April 18, 2013

Subject: Case File Review for SLIC Case RO0002896 and GeoTracker Global ID T06019794669, Red Star Yeast/1396 Fifth Street LLC, 1396 5th Street, Oakland, CA 94607

TECHNICAL COMMENTS ON REVISED EXCAVATION REPORT DATED MARCH 21, 2013

**FIGURE 4
AREAS OF EXCAVATION
COMMERCIAL PROPERTY
1396 5th Street
Oakland, California**

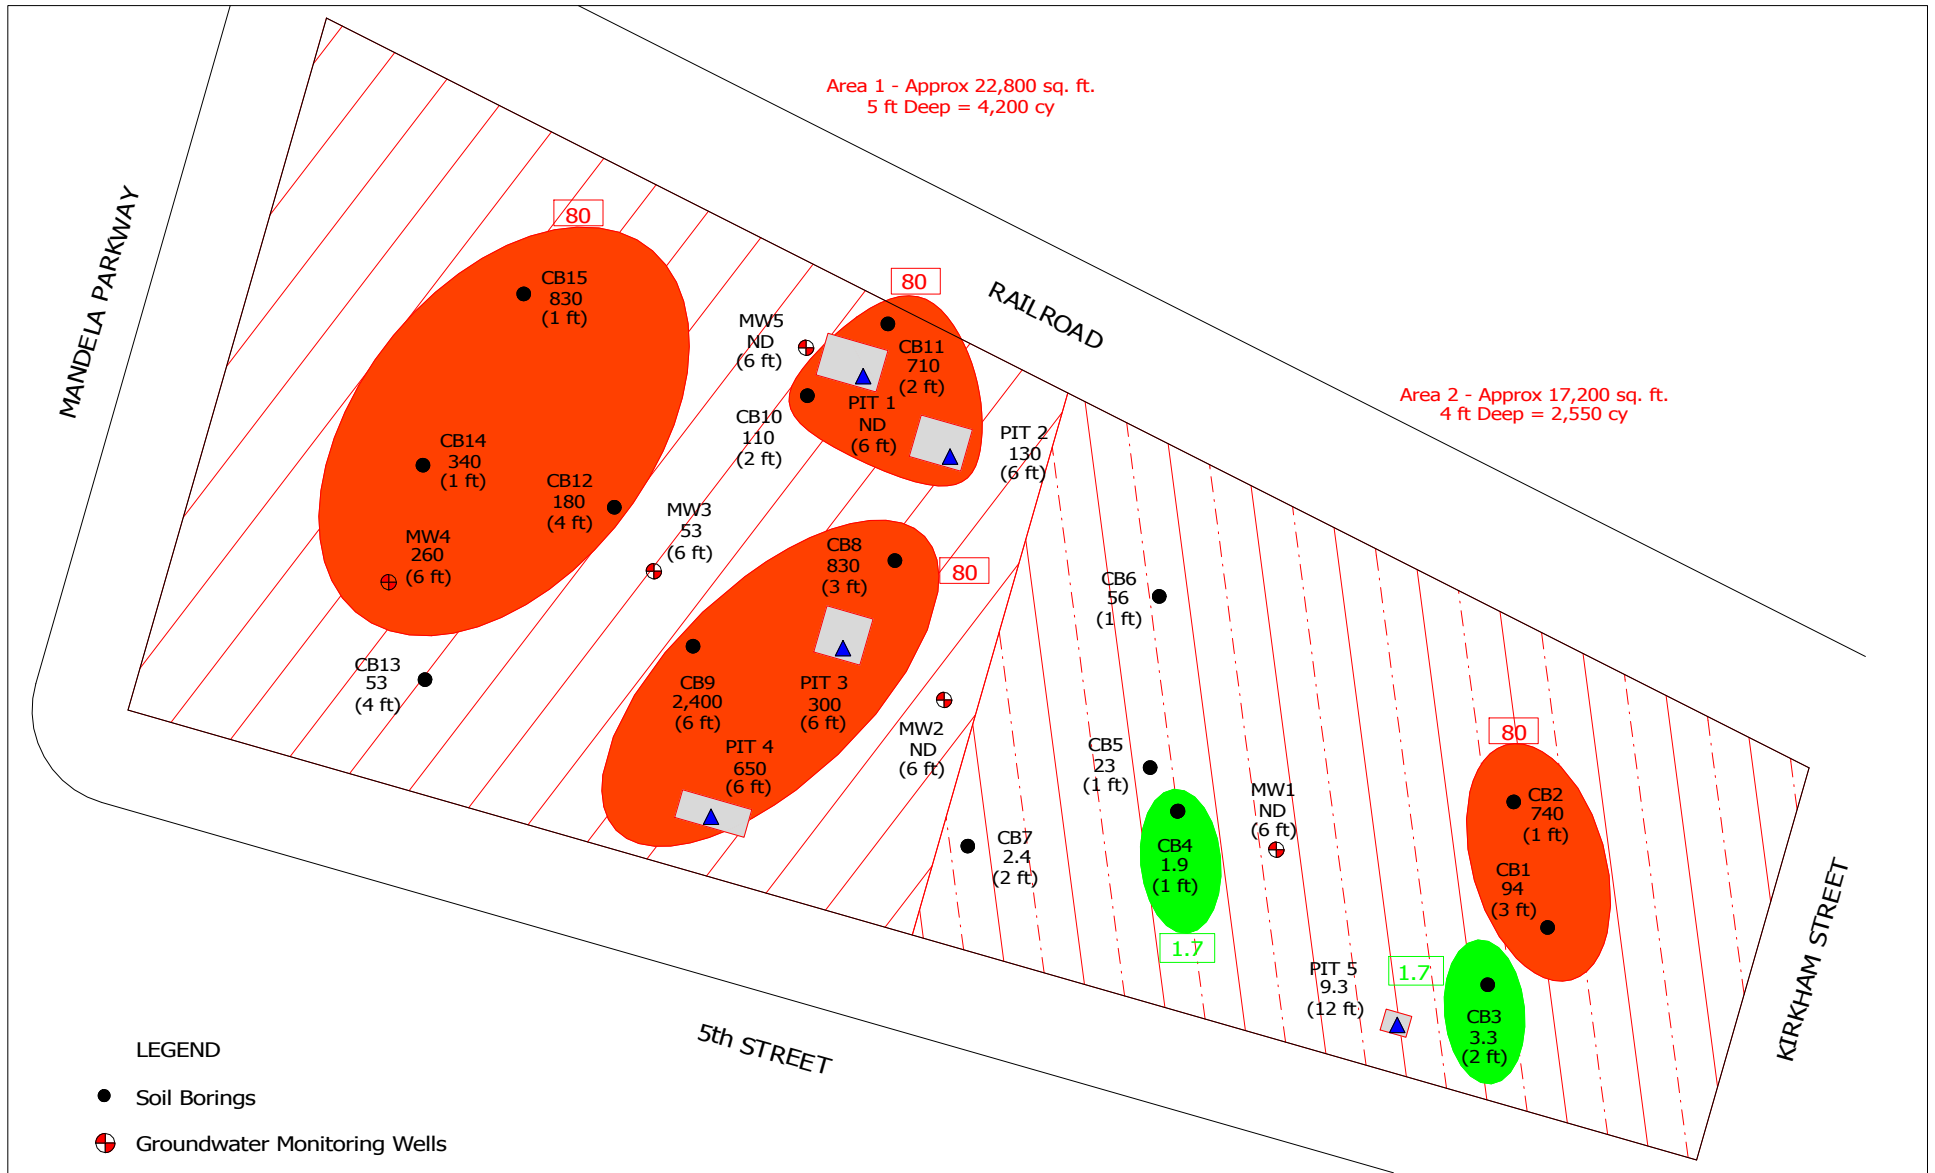
2. **Figure 4 - Confirmation Sampling Results.** Please revise Figure 4 to include the following:
 - Accurate boundaries for the excavation including depiction of sloped surfaces at the edge of the excavation.

- Clear indication on Figure 4 or a separate figure where fill material was left in place.
 - Sidewall sample locations in addition to bottom sample locations.

3. **Excavation on East Side of Site.** Figure 4 of the Revised Excavation Report shows the site being divided into three sections for the purpose of illustrating the extent of excavation. The “West Side Excavation” and “East Side Excavation” are generally consistent with the proposed removal of contaminated fill material. The easternmost section of the site labeled “Target Excavation of CB1-CB3” shows an outline that does not extend to the edges of the site. This extent is not consistent with the proposed extent of excavation shown on Figure 4 of the “Revised Remedial Action Plan” dated July 7, 2011 (attached) and Figure 4 shown in the previous report. This extent is also not consistent with the removal of contaminated fill material throughout the site. Six sidewall confirmation samples appear to have been collected from the Targeted Excavation on August 18, 2011. Lead concentrations in two of the six confirmation soil samples exceeded the screening level of 80 milligrams per kilogram. Please revise the report to include the following information or clarifications:

- Confirm whether fill material was left in place outside the boundary of the Targeted Excavation shown on Figure 4.
 - Prepare a separate figure that clearly shows the depth of excavation throughout the site including sloped surfaces.

- If fill material was left in place within the Targeted Area of Excavation, will any of the fill be exposed in landscaped areas of the development?
4. **Excavation on West Side of Site.** Figure 4 of the Revised Excavation Report shows an approximately 10 foot-wide area parallel to Mandela Parkway that appears to be outside the area of excavation. This area is not discussed in the report text. In the Revised Excavation Report requested below, please include the following:

- Please check the excavation boundary along Mandela Parkway and indicate whether the 10-foot wide strip represents fill at the surface or whether the excavation was sloped away from Mandela Parkway.
